BEFORE THE
UNITED STATES NUCLEAR REGULATORY COMMISSION

PROPOSED AMENDMENT NO. 70
FACILITY OPERATING LICENSE NO. NPF-14
SUSQUEHANNA STEAM ELECTRIC STATION
UNIT NO. 1

This amendment contains a revision to the Susquehanna SES Unit 1 Technical Specifications.

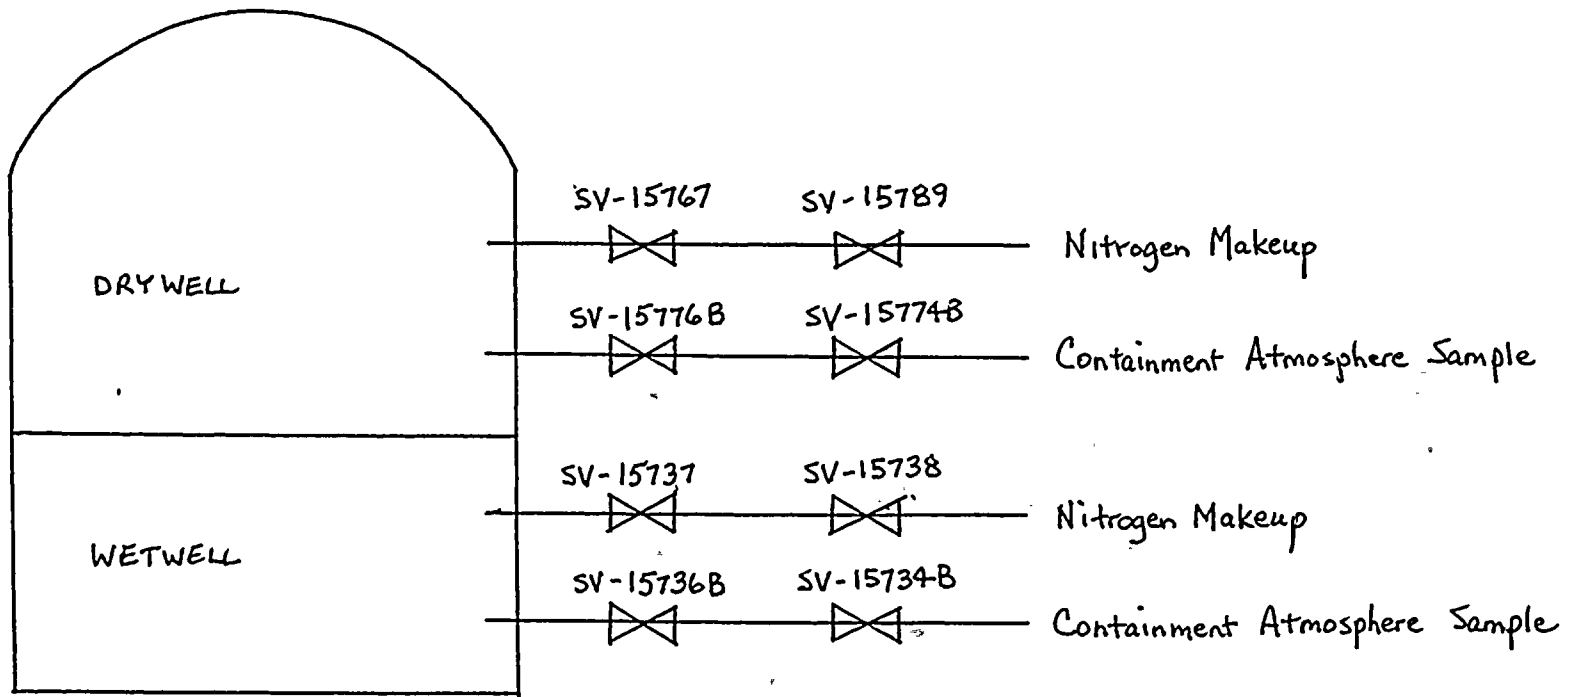
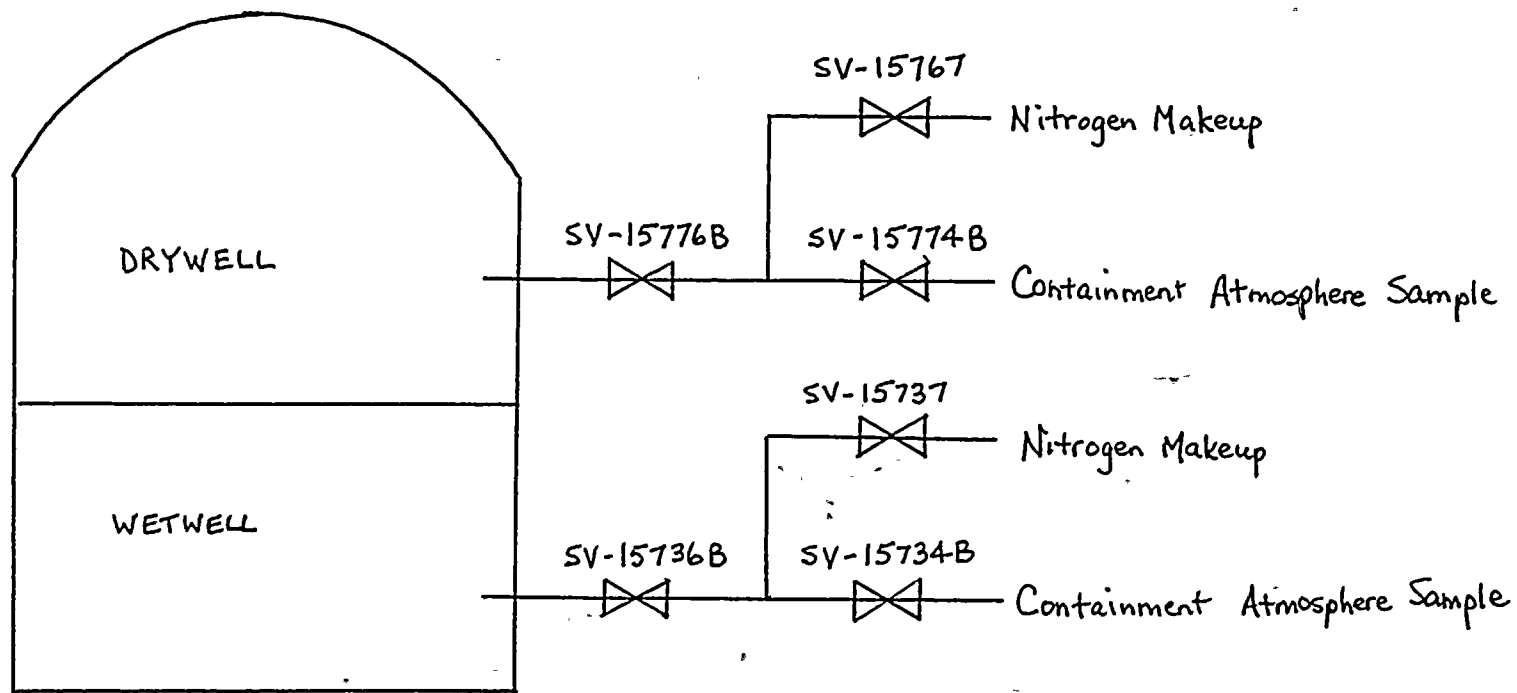
REVISED CONFIGURATION

EXISTING CONFIGURATION
